Rear 227-229 DANFORTH STREET

Subject: Permit for construction
of wood fire escape on side of
apartment house at rear 227
Danforth Street

File: AFR-227 Danforth Department of Building Inspection
(Fire-Escape)

Subject: Application for permit for
wood fire escape on side of apart-
ment house at rear 227 Danforth St.

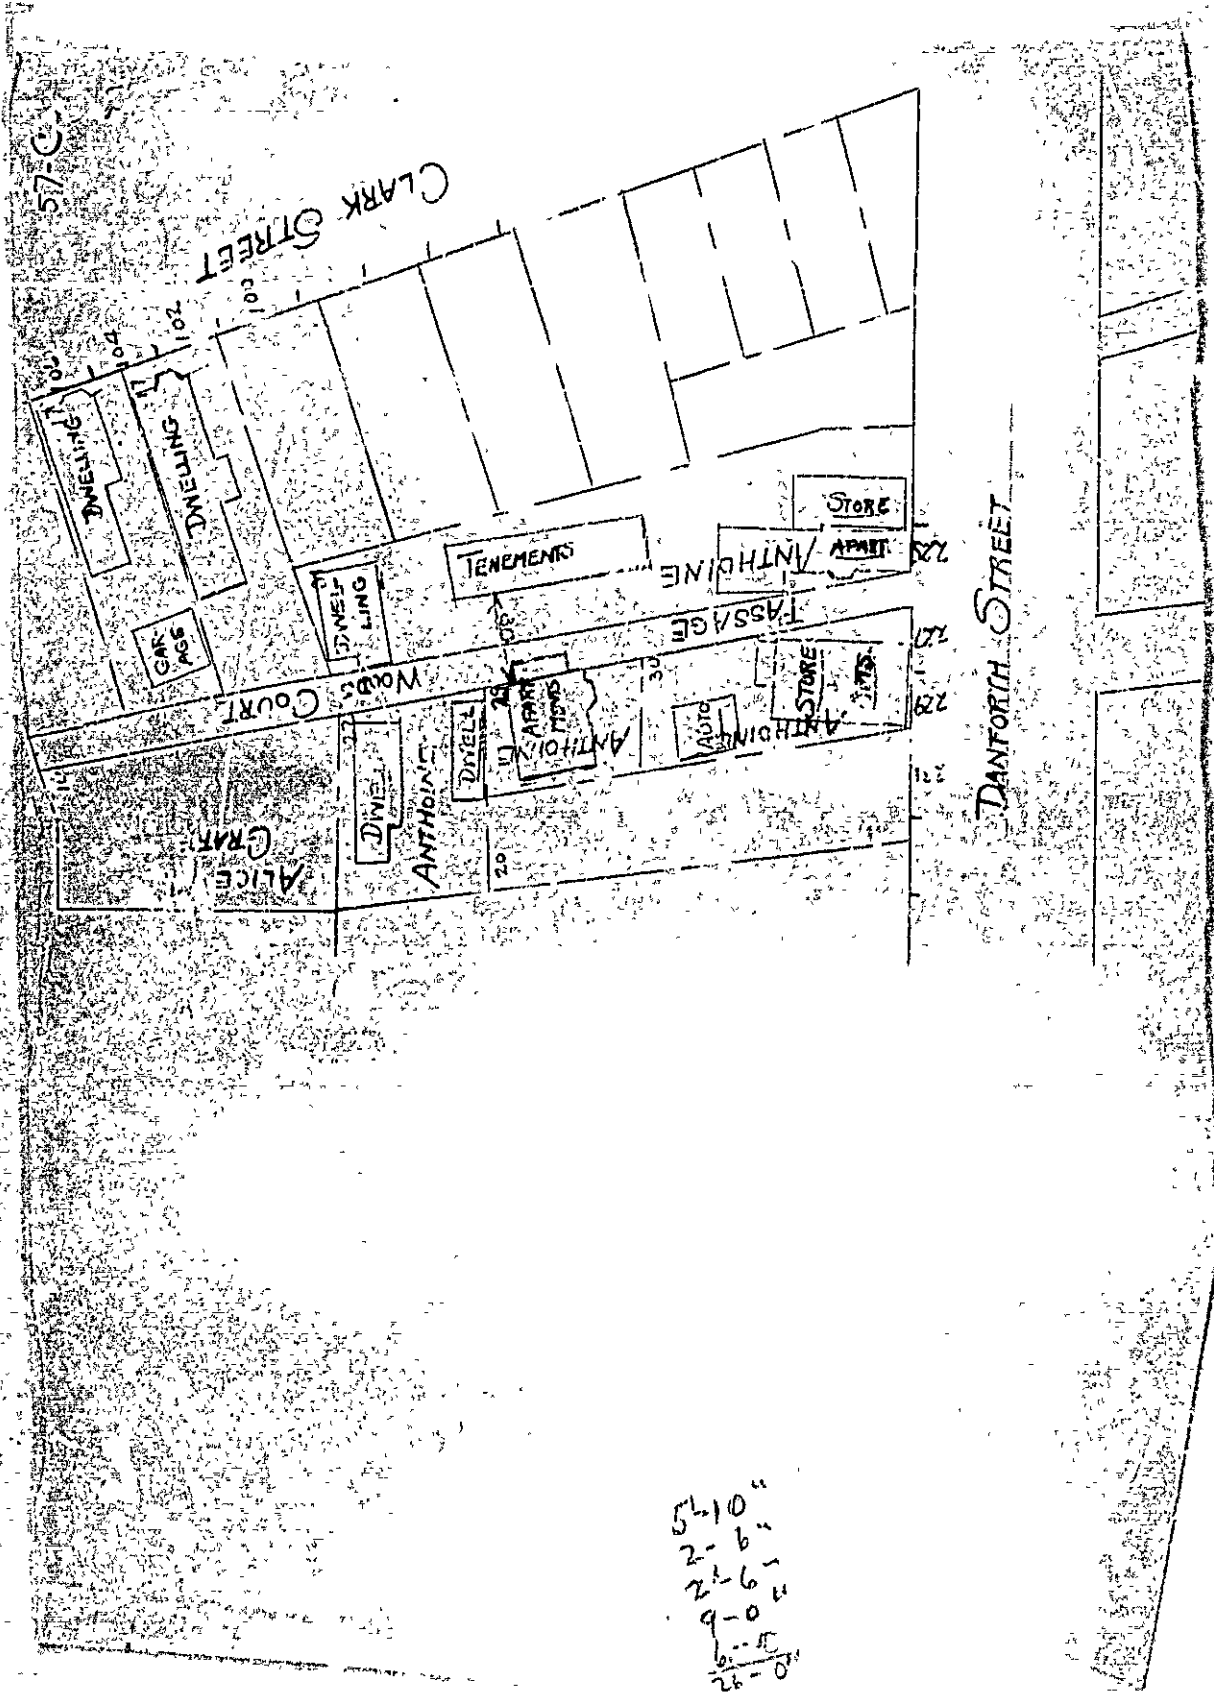
It is noted that the farther end of the two posts supporting the upper platform is shown tied back to the house by a 2x6 at about the center of its height. However, in the location shown it would interfere with the operation of the drop ladder. Therefore it must be placed high enough to avoid interference with the ladder and we suggest that the splice be provided at this point rather than lower down as shown.
